Certificate of Appropriateness

2118 E. LAFAYETTE PL. North Point South Historic District

PTS ID 114340 Rebuild and repair front porch & entry arch

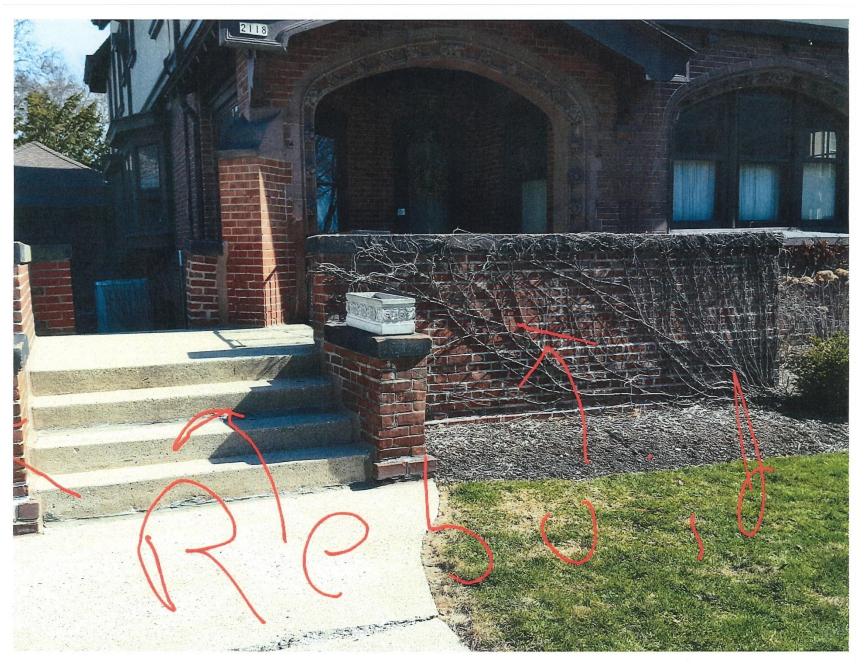
All cravings to be duplicated exactly or re-used.

Two color mortar test panel. Sandy color at left is to be used. Also showing typical wall condition with mismatched mortars from previous attempts at repairs.
